CITY OF VANCOUVER
POLICY REPORT
DEVELOPMENT AND BUILDING

TO: Vancouver City Council
FROM: Director of Current Planning
SUBJECT: CD-1 Rezoning – 5541-5675 Willow Street

Sheet: A3.2

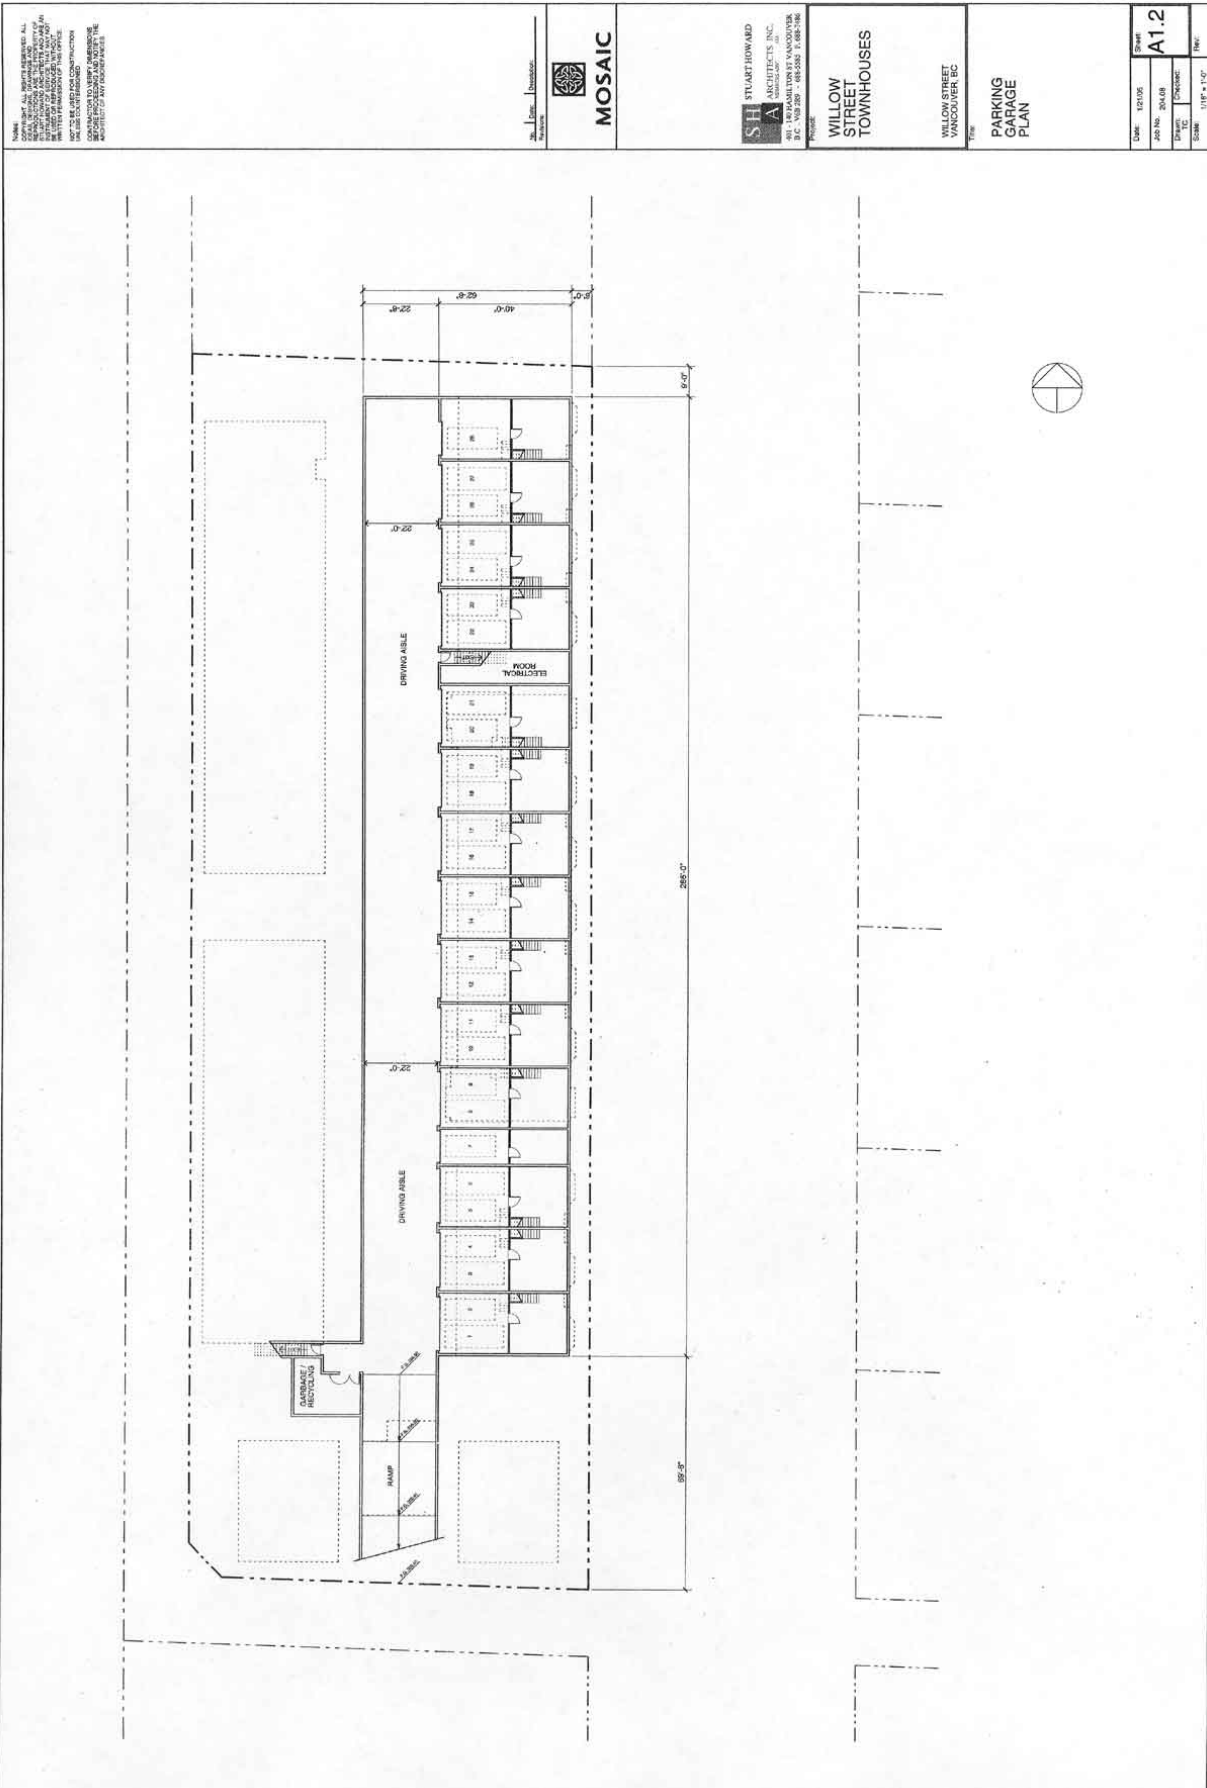
- concerns expressed about the south elevation both in terms of planning and with respect to the unit over the ramp and the height and massing of the southeast unit;

In general, the massing was thought to work quite well with the exception of the south elevation where the units seem to be "squeezed" and have an awkward orientation to the courtyard. The three storey massing of the unit at the southeast corner was also thought to be negative, with recommendations to reduce this unit to two storeys to match the rest of the massing along Willow Street. Another suggestion was to absorb the south units into the front and rear rows, which would also allow the creation larger gaps and east-west links through the site.

- (i) Design development to reduce the floor area to comply with the maximum 1.00 FSR.
- (ii) Design development to comply with the revised north side-yard setback of 3.05 m (10 ft.).
- (iii) Design development to the building massing and height, south elevation.

Note to Applicant: Reduce height of southeast unit to 2½ storeys as seen from Willow Street. Building massing to be more compatible with the east and west facing units. Consider reorientation of buildings to the courtyard, and reconfiguring the parking ramp as necessary to reduce visual impact where possible.
